RE: Columbia Union College Broadcasting, Inc.
WGTS-FM, Takoma Park, Maryland
File No. BPED-930723MB

AMENDMENT TO APPLICATION

WGTS-FM, TAKOMA PARK, MARYLAND

File No. BPED-930723MD

VERTICAL PLAN SKETCH OF PROPOSED ANTENNA AND SUPPORT STRUCTURE

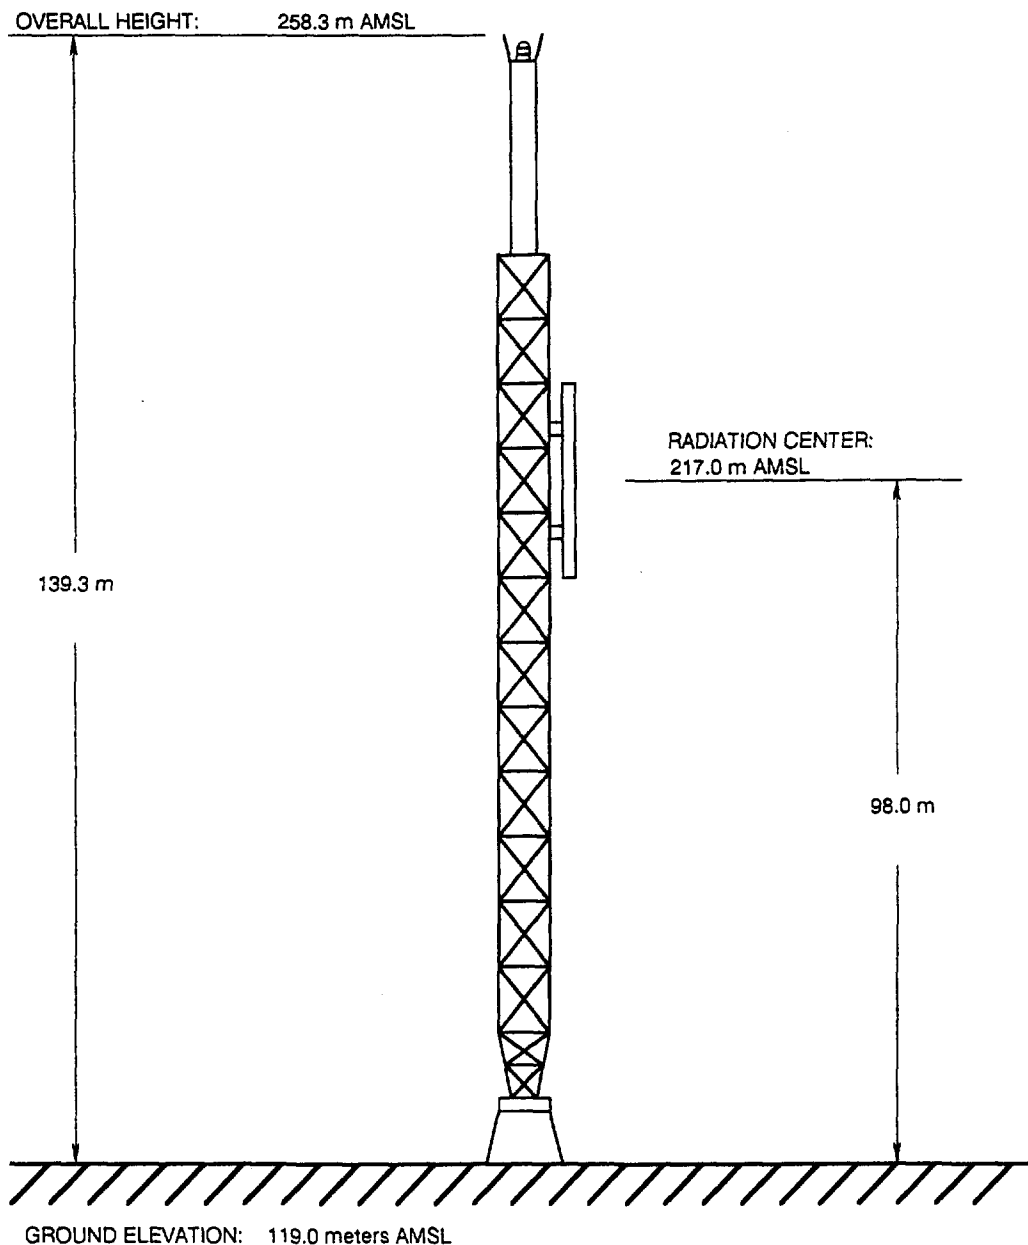
1. Page 2 of Section V-B is replaced so as to report corrected values for the elevation of the top of the tower supporting the proposed antenna above ground level and above mean sea level in Item 7(a)(2) and (3).
2. A revised tower sketch is provided to replace the original sketch to reflect the corrections made in Item 7(a)(2).
3. Engineering Exhibit No. 4 is replaced with a new coverage contour map. It was discovered that the contour shown on the original map was incorrectly drawn.
